## NEW FEATURES

### ■ C59 MANUAL TRANSAXLE

181CH04

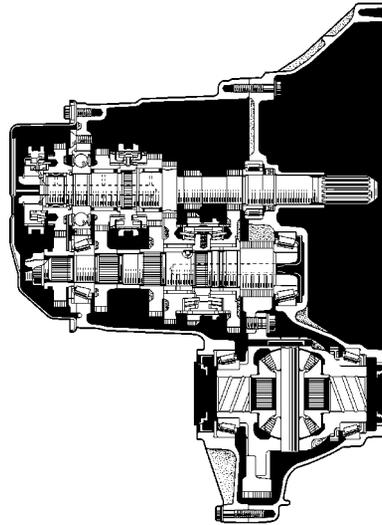
The shift mechanism of the C59 manual transaxles has been partially changed as described below, in order to improve the ease of operation.

- The support for the shift and select lever has been changed.
- The shape of the synchronizer ring for the 3rd and 4th gears has been changed.

257CR03

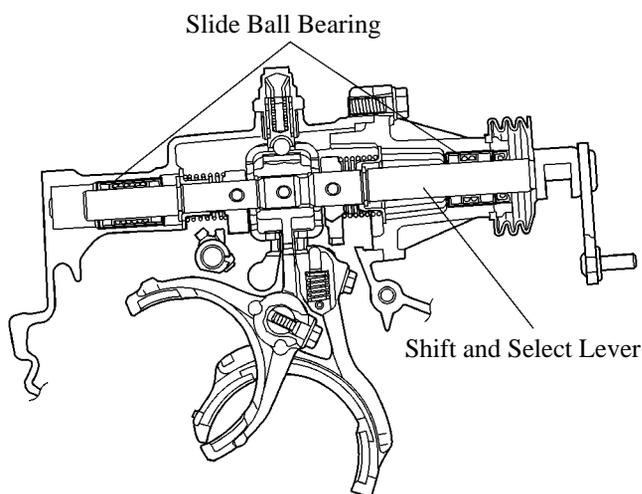
The support for the shift and select lever has been changed from a bushing to a bearing, which reduces the amount of effort required for shifting, thus improving the ease of operation.

Model	'04 Corolla	'03 Corolla
	Slide Ball Bearing	Bimetal Formed Bush
Front	 <p>257MA29</p>	 <p>257MA26</p>
Rear	 <p>257MA28</p>	 <p>257MA26</p>
